INDESIT company

ARTL83EU/HA

F060611

1260310 Exploded views

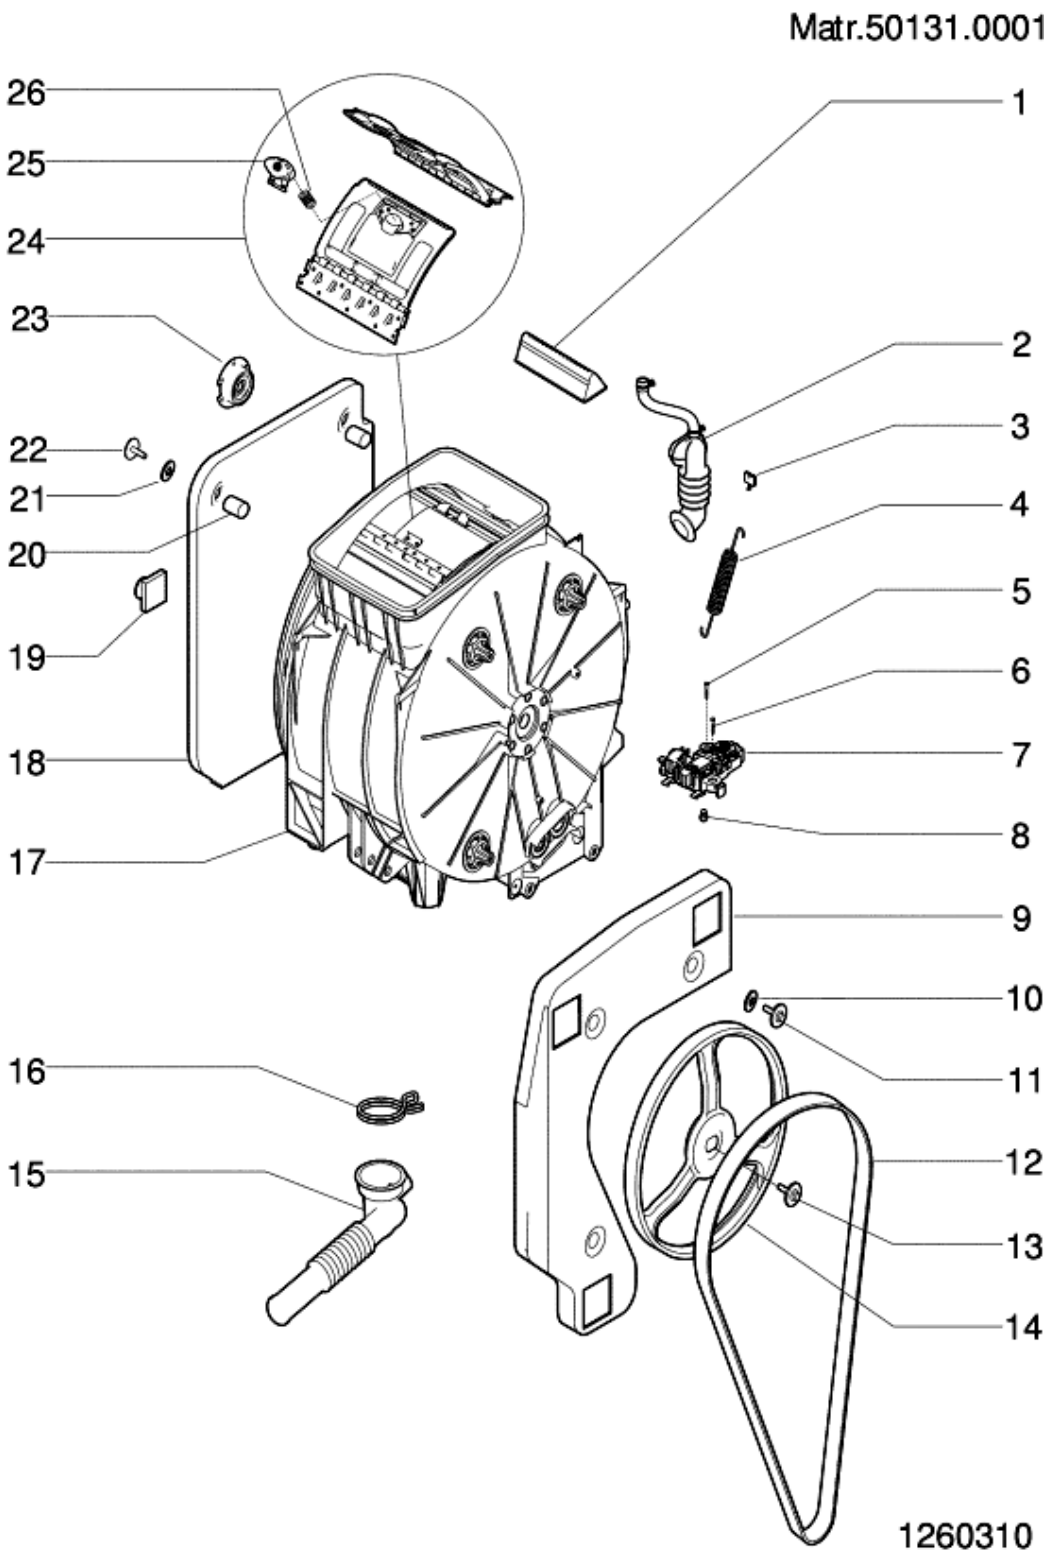
n4009a02: Motor fixing changed on Top Loading washing machines

Top Loading washing machines have changed the fix of motor to the tub.
The tub design is changed in the motor fixing side and two new screws code C00268497 are introduced instead of the old screws C00084333 and the old nut:

C00266015 nut of products with Triphase motor;

C00258673 nut of products with Collector motor.

Spare parts warehouse will go on to manage only the new tubs with the same spare part codes:

C00111505 - Tub 600/1000 rpm

C00111573 - Tub 1200 rpm

C00252343 - Tub 1400 rpm

In assistance on premodification products with the new tubs, you have to fix the motor using the new screws C00268497 instead of the screws and nut that you find in the product.
